Product Change Notification: P-26-030555

General Product Description:
040 MULTILOCK PLUG 12P (174045-2/-4/-5) Change Packaging Form

Other attachments:
[Before and After change](#)

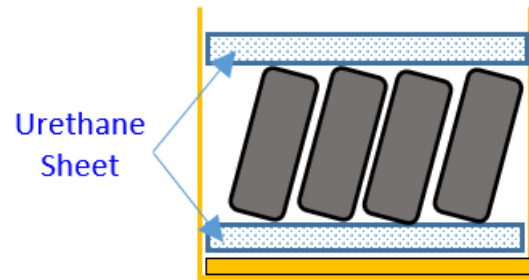
Description of Changes
Following packaging changes will be made for parts produced from TE Thailand Manufacturing Plant to optimize the packaging form. 16 small air cap bags are replaced with 1 large poly bag, remove inner box and urethane sheet, add air cap sheet. Qty/box unchanged. Change carton size from 477Lx309Wx305H to 395Lx295Wx300H. Reduce box weight from 5.80kg to 5.10kg. To align with TE Greensboro and TE China packing method. No change to product form, fit and function. An internal release based on our specifications will be executed before any parts will be delivered. PPAP will not be submitted since there is no change to product form, fit and function. PCN is considered accepted if we did not receive any response within 90 days of this PCN issued date. Change will be implemented on First Date To Ship. If you have any technical questions, please contact Wichanee <wichanee.tm@te.com>. If you have any questions relating to delivery and switchover timing, please contact your TE sales representative.
